PIC16C72 Rev. A Silicon Errata Sheet

The PIC16C72 (Rev. A) parts you have received conform functionally to the Device Data Sheet (DS30390E), except for the anomalies described below.

FIGURE 1: SCK PULSE VARIATION USING TIMER2/2

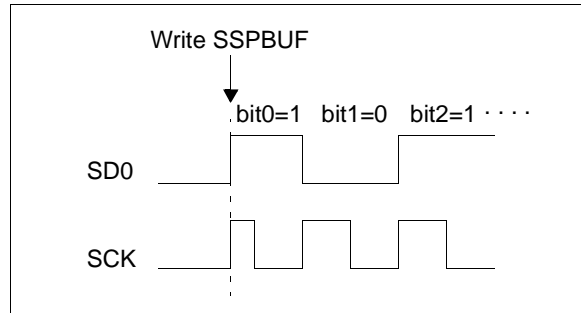
When the SPI is using Timer2/2 as the clock source, a shorter than expected SCK pulse may occur on the first bit of the transmitted/received data (Figure 1).

To avoid producing the short pulse, turn off Timer2 and clear the TMR2 register, load the SSPBUF with the data to transmit, and then turn Timer2 back on. Refer to Example 1 for sample code.

FIGURE 1: WRITES TO TIMER1 (EXTERNAL CLOCK/OSCILLATOR MODE)

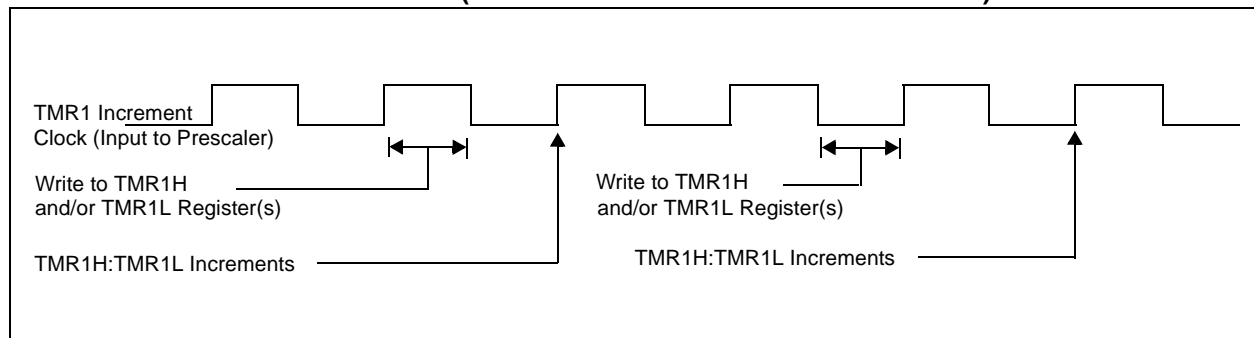
The operation of Timer1 needs some clarification when the timer registers are written when the TMR1ON bit is set.

The internal clock signal that is the input to the TMR1 prescaler affects the incrementing of Timer1 (TMR1H:TMR1L registers and the Timer1 prescaler). When the Timer1 registers are NOT written, the Timer1 will increment on the rising edge of the TMR1 increment clock.

When the TMR1H and/or TMR1L registers are written while this clock is high, TMR1 will increment on the next rising edge of this clock.

When the TMR1H and/or TMR1L registers are written while this clock is low, TMR1 will not increment on the next rising edge of this clock, but must first have a falling clock and the rising clock, for TMR1 to increment.

Figure 1 shows the two cases of writes to the TMR1H and/or TMR1L registers. Due to the V_{IH} and V_{IL} thresholds on the oscillator/clock pins, external Timer1 oscillator components, and external clock frequency, the Timer1 increment clock may not be of a 50% duty cycle.

The TMR1 increment clock is out of phase of the T1OSO/T1CKI pin by a small propagation delay.
